Application for Works Approval

Works Approval Number	W6909/2024/1
Applicant	Brajkovich Landfill & Recycling (Muchea) Pty Ltd
ACN	663 397 555
File number	DER2023/000771
Premises	88 Caladenia Close LOWER CHITTERING WA 6084 Legal description - Lot 9001 on Deposited Plan 71254 Certificate of Title Volume 2789 Folio 776 As defined by the premises map in Schedule 1
Date of report	25 July 2024
Decision	Works approval granted

Figure 1: Infrastructure and operations layout

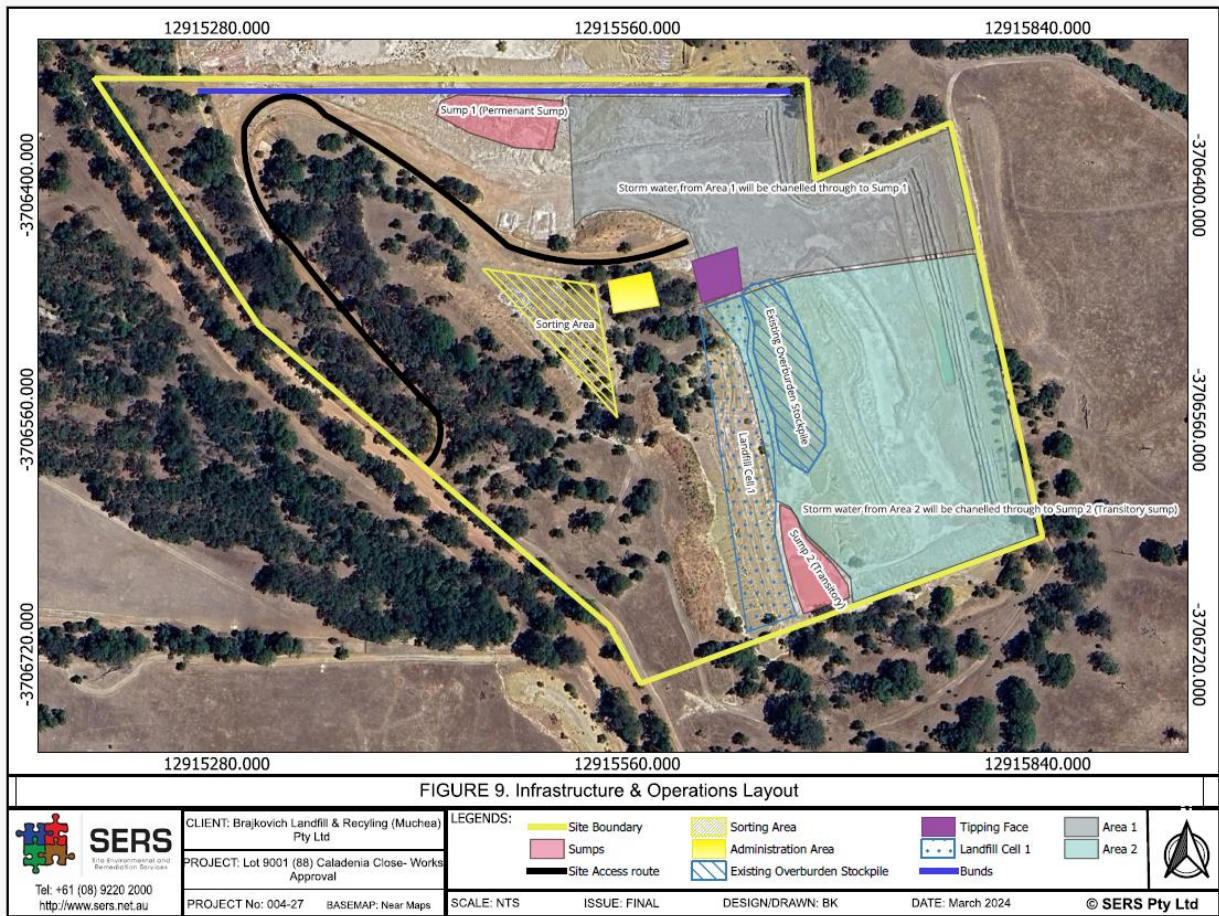
Condition	Summary of applicant's comment	Department's response
1	<p>Comments from the applicant in relation to the draft works approval and draft decision report were received on 22 July 2024.</p> <p>The applicant advised that the stormwater drainage plan originally provided was incorrect. The stone pitch detail in the embankment design is problematic from an ongoing management perspective. A new stormwater drainage plan was provided by the applicant without the stone pitch embankment as a replacement. Confirmation from a civil engineer has been provided to DWER to confirm that stone pitching is not necessary in the construction of the drainage basins.</p> <p>The applicant confirmed that the removal of the requirement for stone pitching was the only requested change and the balance of the works approval was acceptable.</p>	<p>The requested change does not change the overall risk profile of the premise. Therefore, the Delegated Officer has resolved to remove the requirement for the basin embankments to be stone pitched.</p>
